12/06/2017
RC/10747

Re: Hall School, Crossfield Road – Daylight and Sunlight matters

Figure 01 – The Proposed Scheme for Hall School

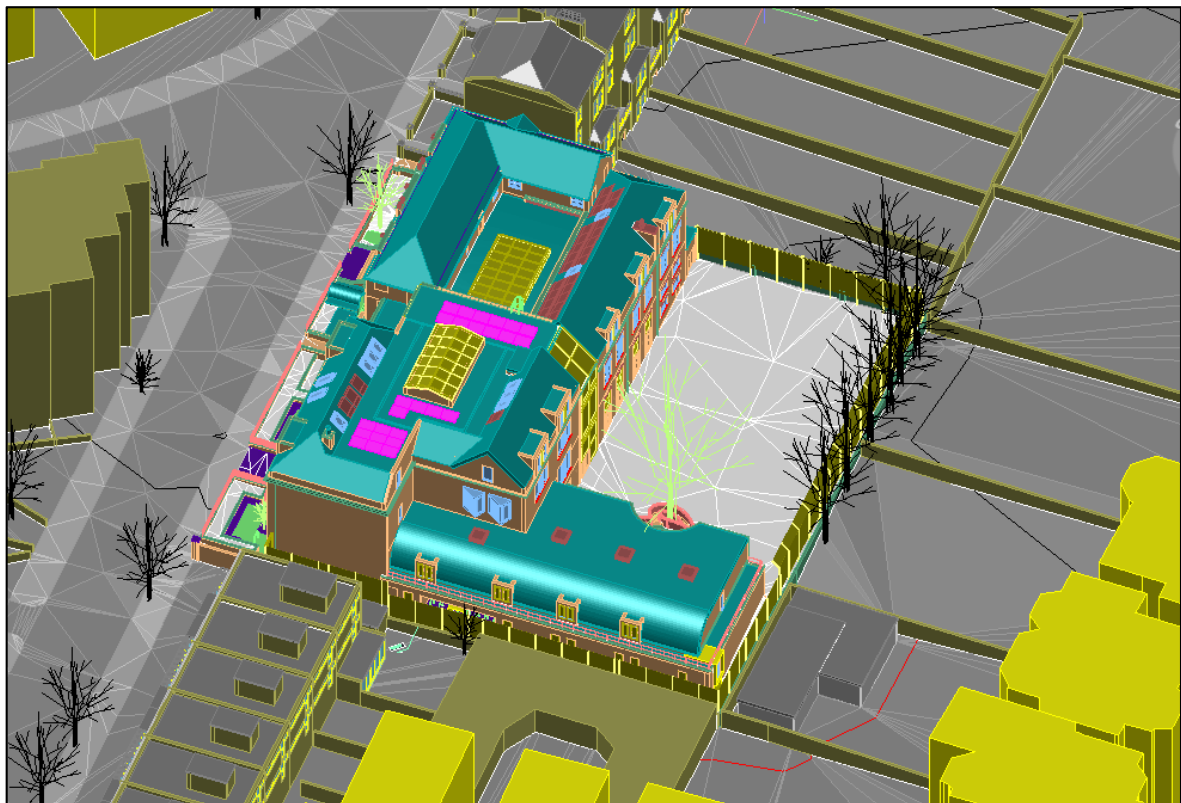
The daylight impact to the Hereward House School art block site-facing windows will be lessened when compared to that of the scheme as per the November Report. This is due to the change in design at the part of the proposed scheme closest to these windows, specifically:

- The stepping back of the first floor away from the art block, to create a "terracing" effect
- The reduction in overall height of this part of the scheme by approximately 1.25m
- The increase in distance between the proposal and the site boundary by approximately 0.6m

This will allow much more daylight to enter the windows here, particularly when compared to the previous scheme design, which featured a taller, full-footprint two storey design closer to the art block. While no technical analysis has been undertaken to quantify how much the impact to these windows will lessen and whether they would be compliant with the BRE target values, we can confidently conclude that there will be a material and noticeable increase in daylight to these windows and in turn the room, and given the additional sources of daylight to the art block (specifically rooflights and the principal windows/sources of daylight to the room being positioned on the opposite façade, facing away from the scheme), the daylight amenity to this room will undoubtedly remain very good, with very high sky visibility. In addition, all rooms within the art block would remain fully compliant with the sunlight criteria, as per the November Scheme.

With regards to the impact to two windows at 24 Crossfield Road, again the proposed changes in the design here from that of the November Scheme would lessen these daylight impacts, owing to the significant scaling back of the massing here. While the purpose of this report is not to quantify any changes in daylight, taking into consideration that the original daylight transgressions were marginal, were one to complete a technical analysis of the proposed scheme it is likely that these transgressions would disappear altogether. However we can confidently conclude that even with the absence of a technical analysis, the daylight to the windows and rooms at this property will improve over that of the November Report, and the daylight amenity to the rooms served by the impacted windows would remain good. Due to the location of 24 Crossfield Road relative to Hall School, this property is not relevant for the sunlight assessment.
